World Forum for Harmonization of Vehicle Regulations

Working Party on General Safety Provisions

Proposal for the 05 series of amendments to UN Regulation No. 46 (Devices for indirect vision)

Submitted by the Informal Working Group on Awareness of Vulnerable Road Users Proximity*

Figure 11
Class VIII field of vision

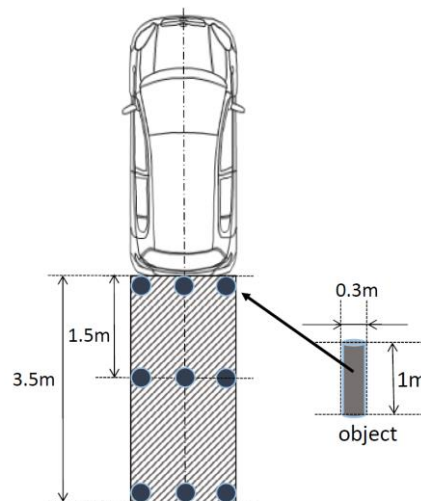
Insert new paragraphs 15.2.4.8. to 15.2.4.8.3., to read (inserting a new Figure 11):

- "15.2.4.8. **Class VIII close-proximity rear-view device**
- 15.2.4.8.1. **The field of vision shall be bounded by the following planes and shall be such that the driver can see at least part of each cylindrical objects with a height of 1,000 mm and a diameter of 300 mm which is located on the ground plane at nine positions within the boundaries of the field of vision as defined in Figure 11 below:**

- (a) A transverse vertical plane through the outermost point of the rear of the vehicle;
- (b) A transverse vertical plane [3,500] mm behind the outermost point of the rear of the vehicle;
- (c) Two longitudinal vertical planes parallel to the longitudinal vertical median plane going through the outermost point of each side of the vehicle.
